COMBINED PRELIMINARY AND FINAL  
DRAINAGE REPORT  
for  
OHANA SUBDIVISION  
EL PASO COUNTY, COLORADO

Allison Engineering  
4245 Log Road  
Peyton, CO 80831

# V4\_Drainage Report Final.pdf Markup Summary

Figure 1: This plat plan is not intended for reference with this report. REFERENCE THE LARGER PRINT THAT ACCOMPANIES THIS REPORT.

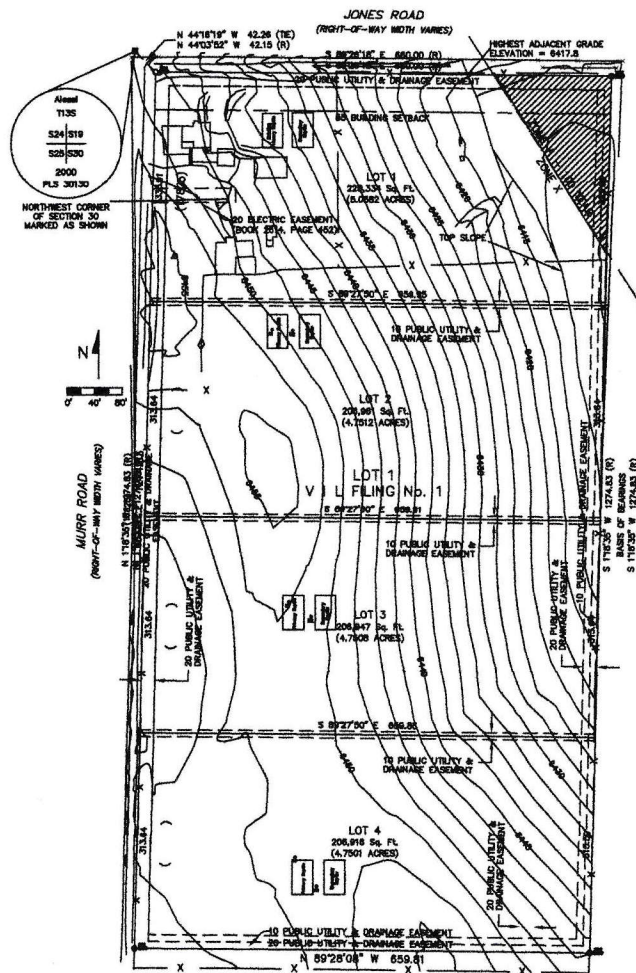
Larger version of this map is missing from appendix. Please provide. Ensure comments from previous submittal have been addressed.

Figure 6: Diagram of the area drained at the existing 16-inch culvert.

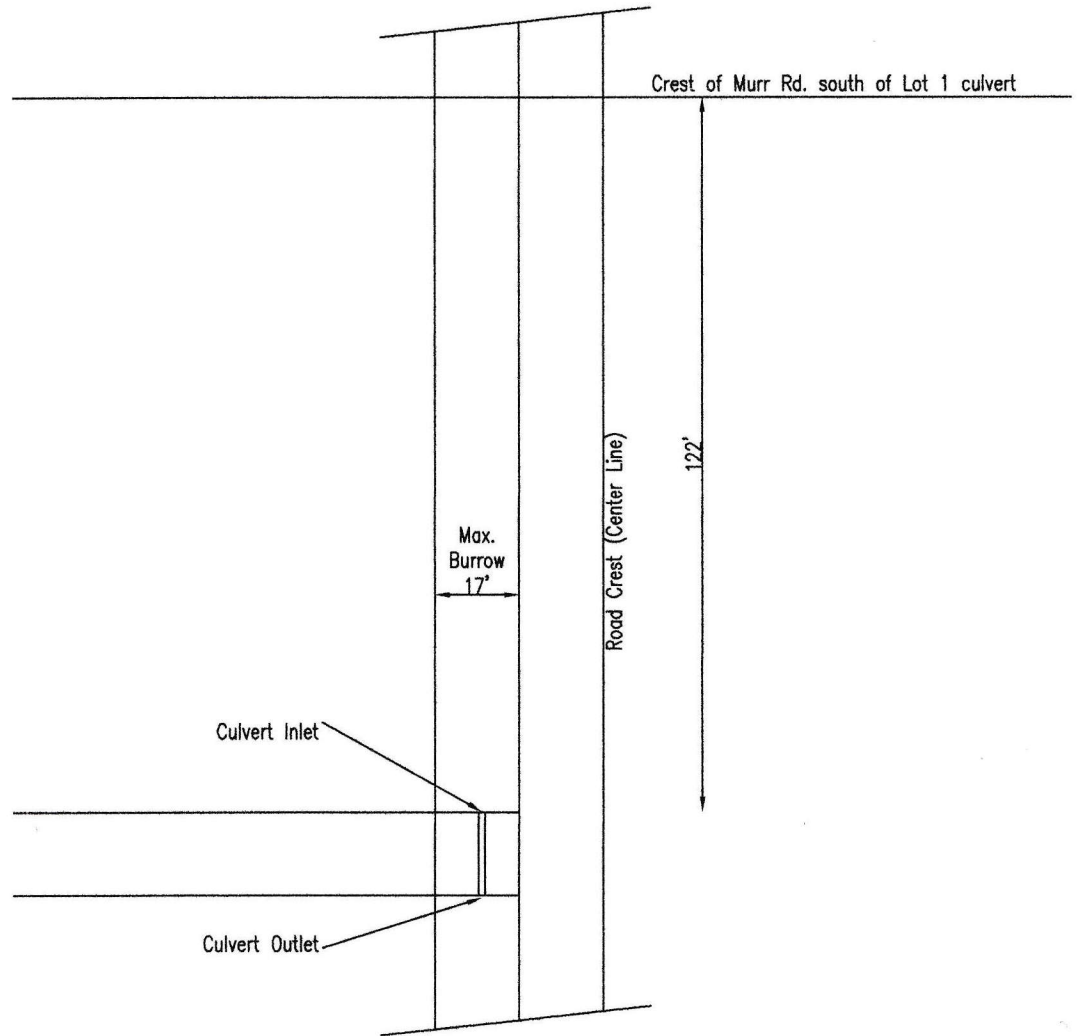
Provide analysis showing 16 inch cmp with a 0.4 cfs flow.

The volumes of water for  $C_{10}$  and  $C_{100}$  are so small the current 16-in diameter culvert is sufficient though the subdivision owners are not opposed to installing an 18-in culvert. The flow of 0.4 cfs for the 100-year event will not require inlet riprap protection.
